Dewberry Response to USGS Review of the FL Panhandle Block 1 2018 Lidar Project

Produced for U.S. Geological Survey

USGS Contract: G16PC00020

Report Date: 12/10/2018

Figure 2 – Location of USGS call for missing waterbody.

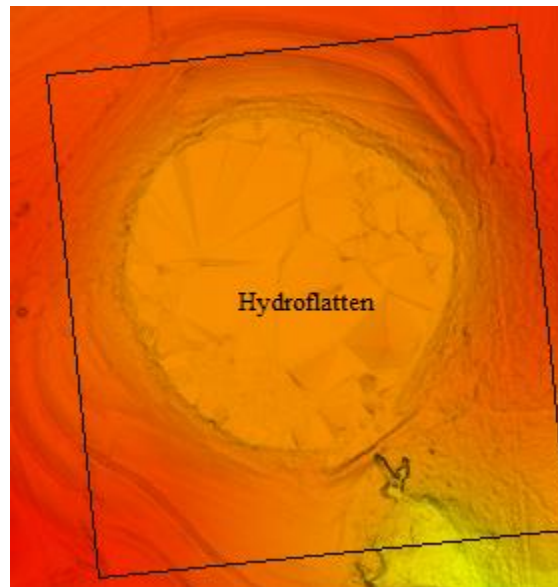
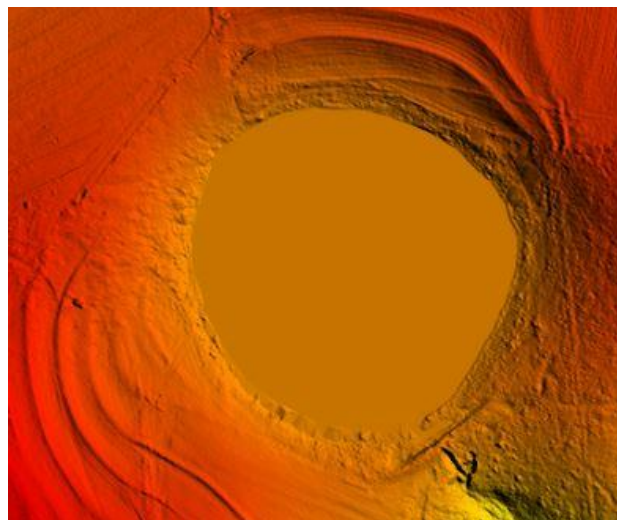
USGS made 38 calls for missing waterbodies requiring hydroflattening. Of the 38 calls, five (5) features were corrected in the LAS and hydroflattened in the final DEMs.

Figure 3 –The waterbody was collected and the impacted DEM has been hydroflattened.

Figure 4 – Location of USGS call for missing waterbody (left) and corresponding intensity imagery (right). These swamps/bog features were investigated by Dewberry and determined to be dry, heavily vegetated locations.

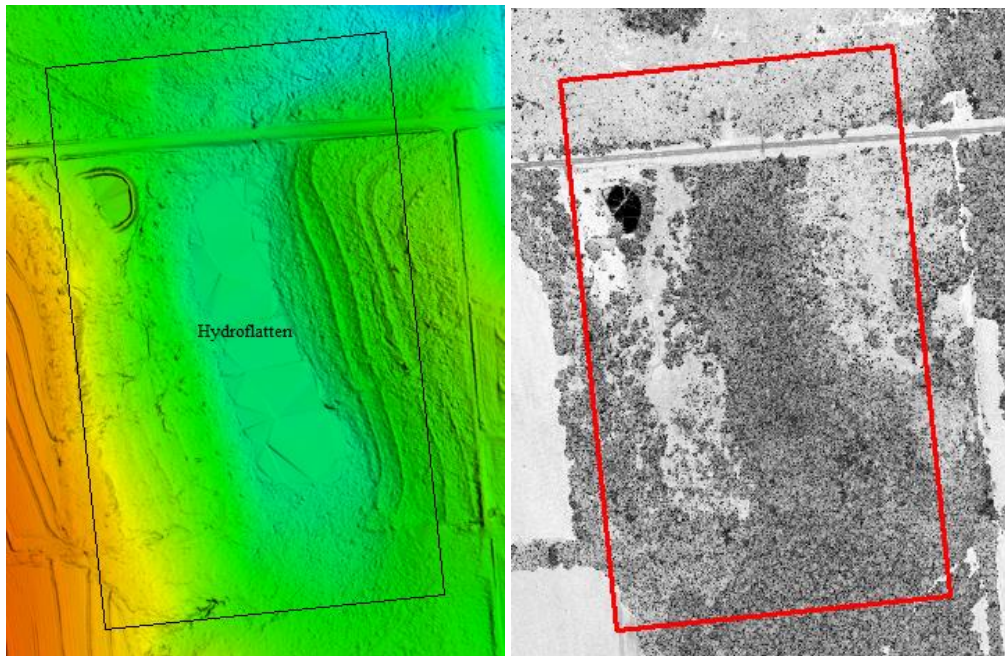
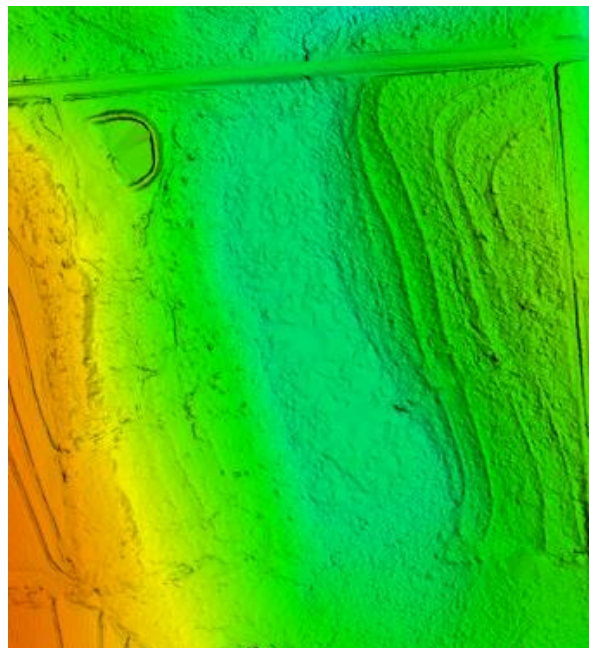
Of the 38 missing waterbody calls, 30 were investigated by Dewberry and determined to be swamps/bog features. These features did not appear wet in the corresponding intensity imagery

and remain modeled as ground. Points were reclassified to ground in the lidar for these features to improve density and better represent them in the final DEMs.

Figure 5 – Ground points were added to the lidar to improve density and representation in the final DEM.

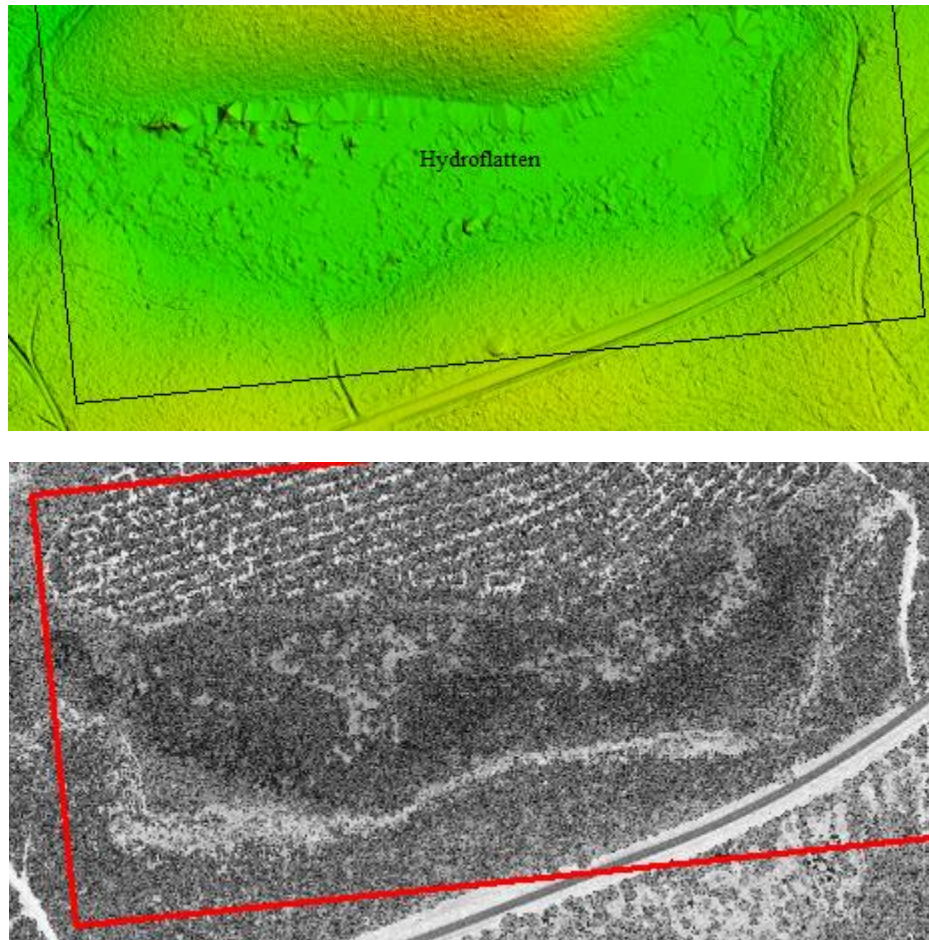
Of the 38 missing waterbody calls, three (3) were investigated by Dewberry and determined to be swamps/bog features. These features did not appear wet in the corresponding intensity imagery and remain modeled as ground. Points were not available to reclassify to ground to improve density in the lidar, so no changes were made to the original lidar and DEMs.

Figure 7 – USGS call location for bridge saddles in the DEM.

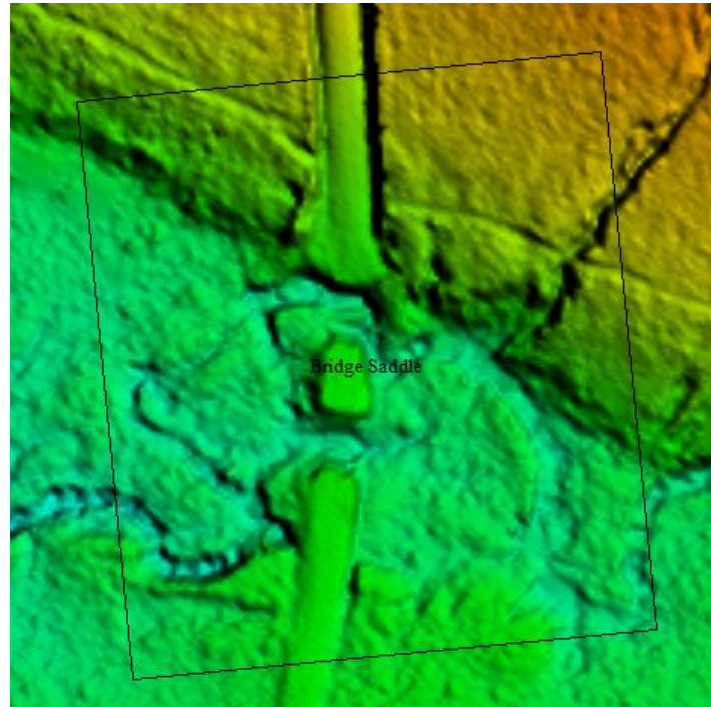
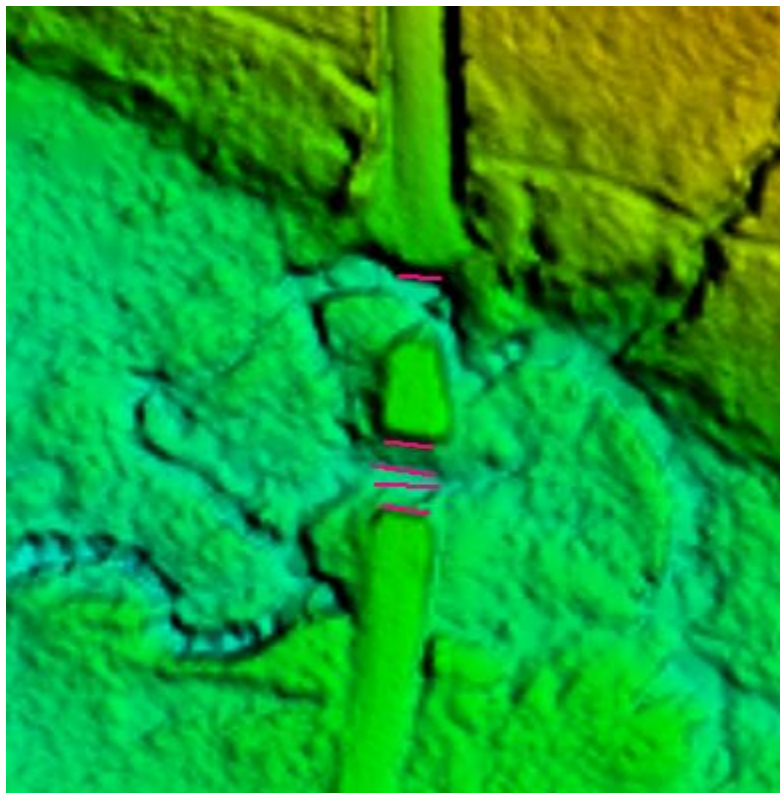
USGS made two (2) bridge saddle calls in the DEMs. Dewberry added bridge saddle breaklines for one of the two bridge saddle calls. The bridge saddles have been corrected.

Figure 8 – Bridge saddle breaklines were added and enforced in the final DEM to remove the bridge saddles.

Figure 9 – USGS call location for bridge saddles in the DEM.

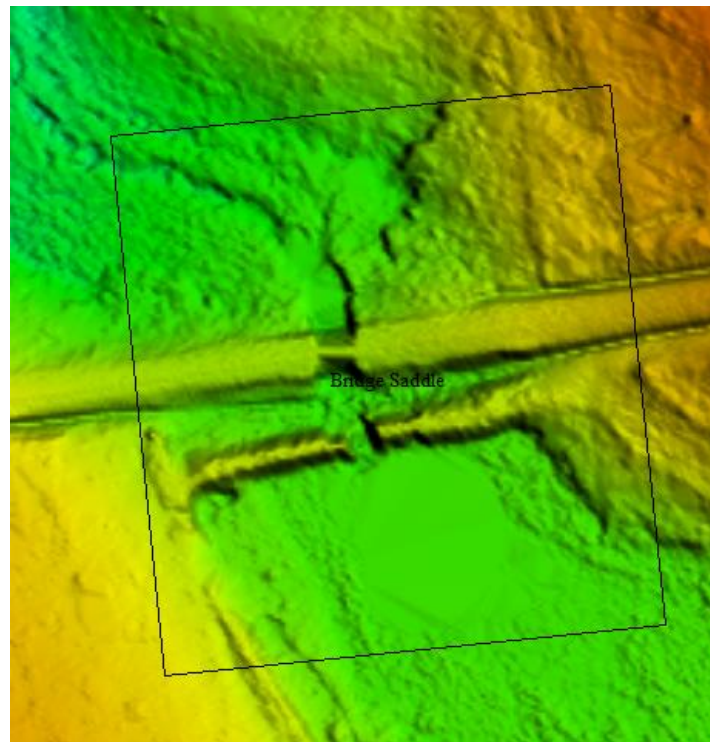
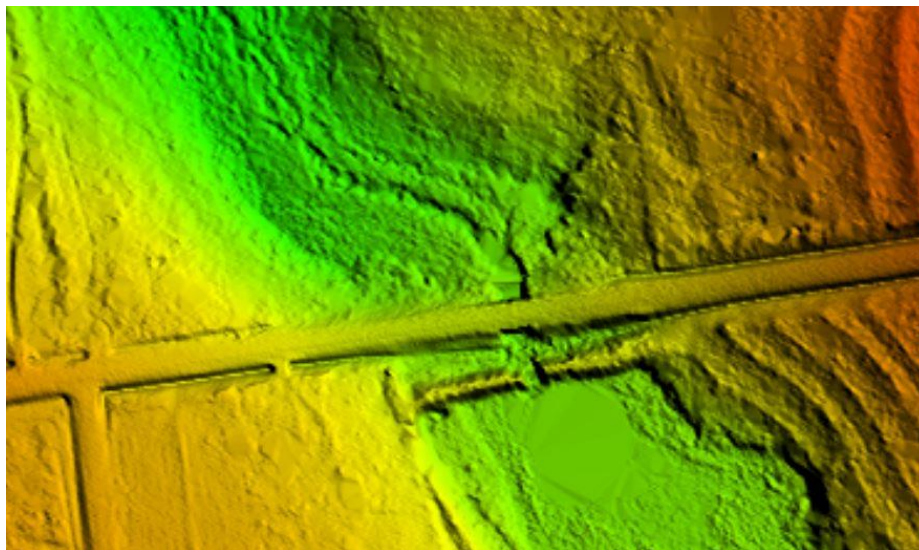
In the second bridge saddle call identified by USGS, the feature was investigated by Dewberry and determined to be a culvert. The feature was reclassified in the lidar to ground.

Figure 10 - The area was examined and determined to be a culvert. The bridge points were reclassified to ground to represent a culvert. Bridge saddle breaklines were not required.
